Title: Data Center Development Standards (Text Amendment)

Meeting and Date: City Council – June 24, 2025

To: City Council
From: Sara Mendez, Senior Planner
CC: Bart Olson, City Administrator
Krysti Barksdale-Noble, Community Development Director
David Hansen, Senior Planner
Date: June 17, 2025
Subject: **PZC 2025-05** Data Center Development Standards – Text Amendment

CYRUS ONE - DATA CENTER

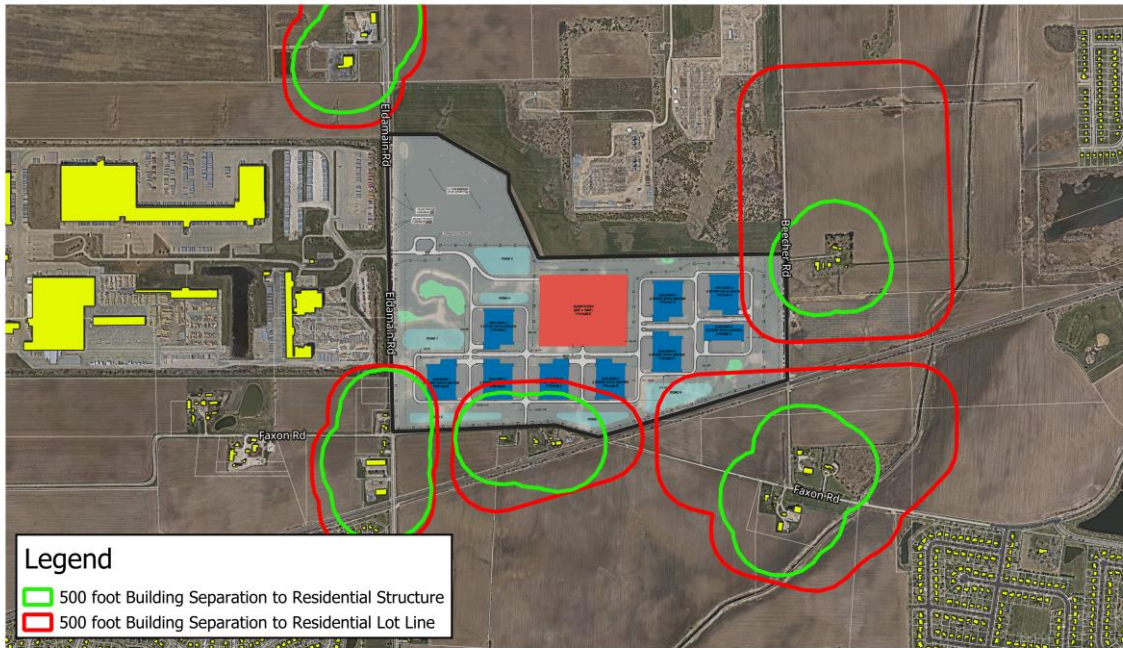
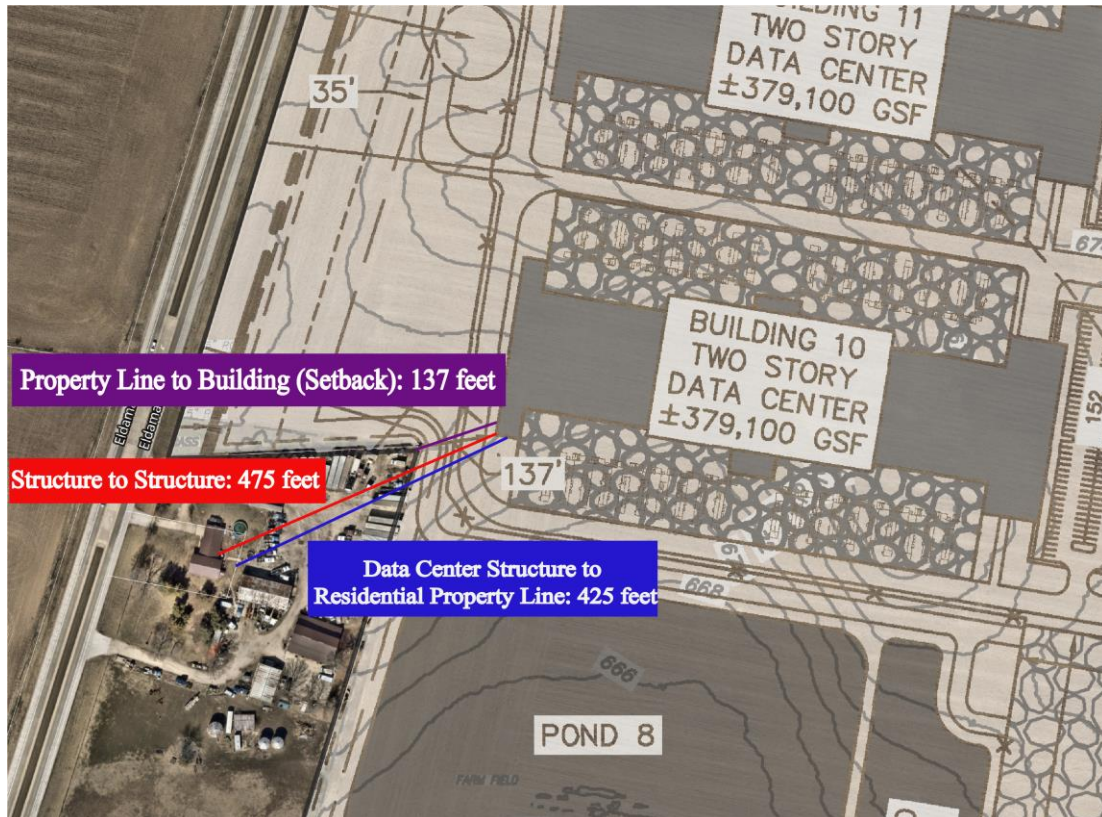
The Cyrus One data center campus was approved by the City in July 2024. The project spans approximately 228 acres and includes nine (9) data center buildings. The map below illustrates the estimated distances between Building #4 of the data center campus and the nearest residential structure (structure to structure), the residential property line (structure to lot line), and the distance from the data center campus property line to the data center Building #4 (setback).

The map below illustrates the distances between the nearest residential structures and the data center buildings within the Cyrus One development, along with buffer areas surrounding nearby residential properties. The green buffer represents staff's proposed 500-foot building separation from data center structure-to-residential structure. The red buffer reflects the updated recommendation from the June 10th City Council meeting, which measures a 500-foot separation from the data center structure to the residential lot line.

Distance	Does the plan meet the proposed 500-foot standard?	Impact
Structure to Structure – Staff’s Proposal	443 feet	No	Below proposed requirement by 57 feet
Structure to Property Line – Proposed from June 10th City Council	302 feet	No	Below proposed requirement by 198 feet
Building to Property Line – Standard in UDO	262 feet	No	Below proposed requirement by 238 feet

As demonstrated in the table above, the site plan falls 57 feet short of staff’s original building-to-building separation. Additionally, the plan does not meet the June 10th City Council recommended 500-foot building to property line falling short almost 200 feet. Finally, if a standard building to property line (setback) were established the proposed plan would fall short over 230 feet. Although Cyrus One’s building-to-building distance does not meet the staff proposed 500-foot separation, the project was approved prior to the adoption of the standard, and the approved site plan is more aligned with staff’s recommended approach than with the revised standard proposed on June 10th.

PROJECT STEEL - DATA CENTER

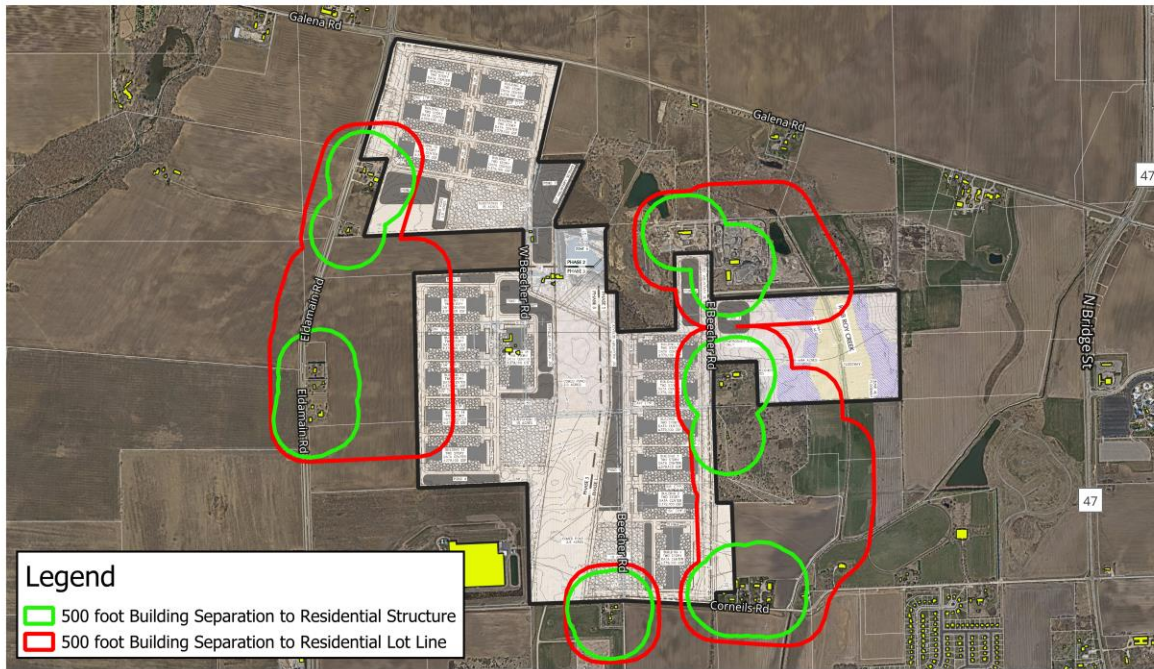
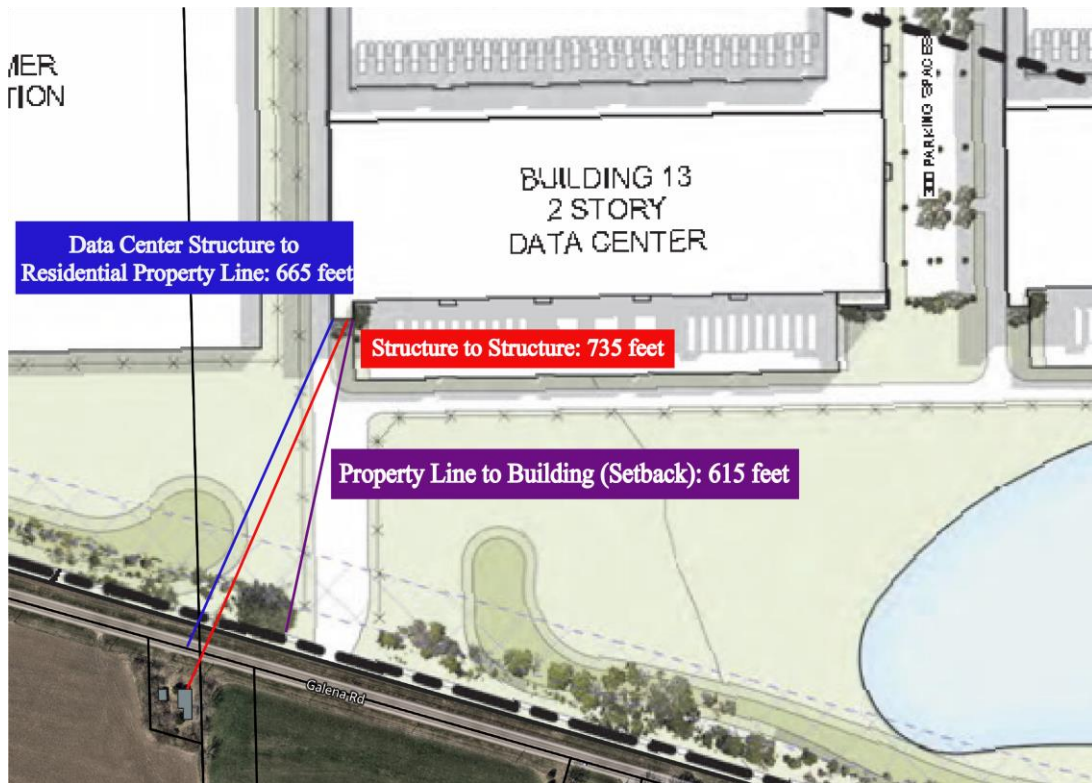
Project Steel, a data center campus, is currently under review. The project spans approximately 540 acres and includes eighteen (18) data center buildings totaling approximately 6.8 million square feet. The map below illustrates the estimated distances between Building #10 of the data center campus and the nearest residential structure (structure to structure), the residential property line (structure to lot line), and the distance from the data center campus property line to the data center Building #10 (setback).

The map below illustrates the distances between the nearest residential structures and the data center buildings within the proposed Project Steel development, along with buffer areas surrounding nearby residential properties. The green buffer represents staff's proposed 500-foot building separation from data center structure-to-residential structure. The red buffer reflects the updated recommendation from the June 10th City Council meeting, which measures a 500-foot separation from the data center structure to the residential lot line.

Distance	Does the plan meet the proposed 500-foot standard?	Impact
Structure to Structure – Staff’s Proposal	475 feet	No	Below proposed requirement by 25 feet
Structure to Property Line – Proposed from June 10th City Council	425 feet	No	Below proposed requirement by 75 feet
Building to Property Line – Standard in UDO	137 feet	No	Below proposed requirement by 363 feet

As demonstrated in the table above, the site plan falls 25 feet short of staff’s original building-to-building separation. Additionally, the plan does not meet the June 10th City Council recommended 500-foot building to property line falling short 75 feet. Finally, if a standard building to property line (setback) were established the proposed plan would fall short over 360 feet. Although Project Steel’s current site plan does not fully meet staff’s proposed 500-foot separation, there is potential to adjust the site plan if necessary. Overall, the proposed site plan aligns more closely with staff’s recommended approach than with the revised standard proposed on June 10th.

PROJECT CARDINAL - DATA CENTER

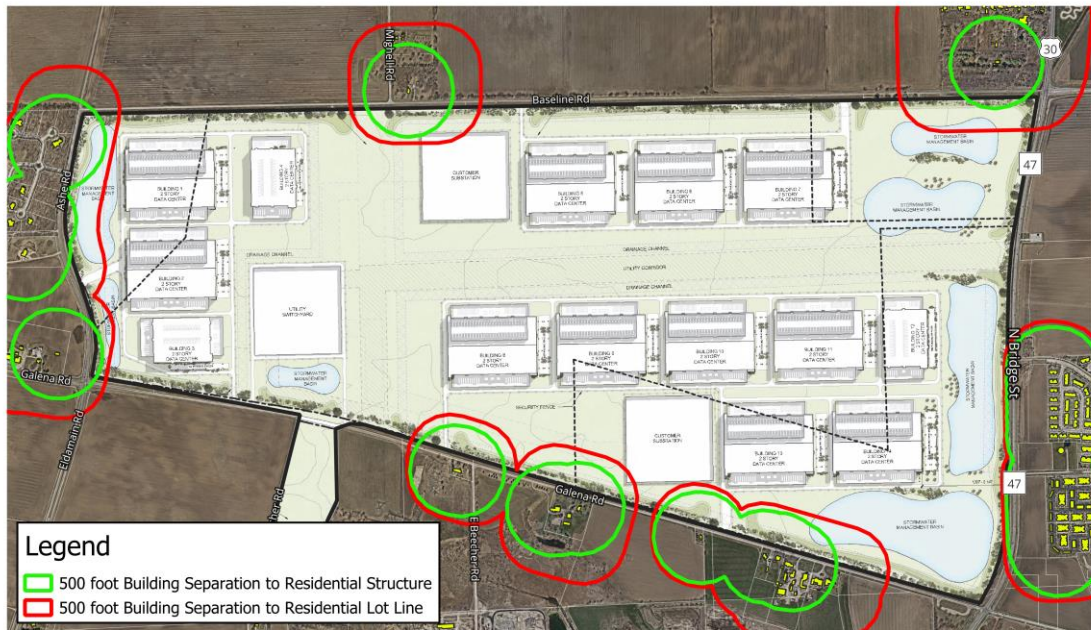
Project Cardinal, a data center campus, is currently under review. The project spans approximately 1,037 acres and includes fourteen (14) data center buildings totaling approximately 17 million square feet. The map below illustrates the estimated distances between Building #13 of the data center campus and the nearest residential structure (structure to structure), the residential property line (structure to lot line), and the distance from the data center campus property line to the data center Building #13 (setback).

The map below illustrates the distances between the nearest residential structures and the data center buildings within the proposed Project Cardinal development, along with buffer areas surrounding nearby residential properties. The green buffer represents staff's proposed 500-foot building separation from data center structure-to-residential structure. The red buffer reflects the updated recommendation from the June 10th City Council meeting, which measures a 500-foot separation from the data center structure to the residential lot line.

Distance	Does the plan meet the proposed 500-foot standard?	Impact
Structure to Structure – Staff’s Proposal	735 feet	Yes	Exceeds proposed requirement by 235 feet
Structure to Property Line – Proposed from June 10th City Council	665 feet	Yes	Exceeds proposed requirement by 165 feet
Building to Property Line – Standard in UDO	615 feet	Yes	Exceeds proposed requirement by 115 feet

As shown in the table above, the recommendation made at the June 10th City Council meeting to measure from the data center structure to the residential property line does meet the 500-foot standard, exceeding it by 165 feet. Additionally, this site plan exceeds staff’s original proposal of a 500-foot building separation by 235 feet and offering the most distance between data center structures and residential structures.
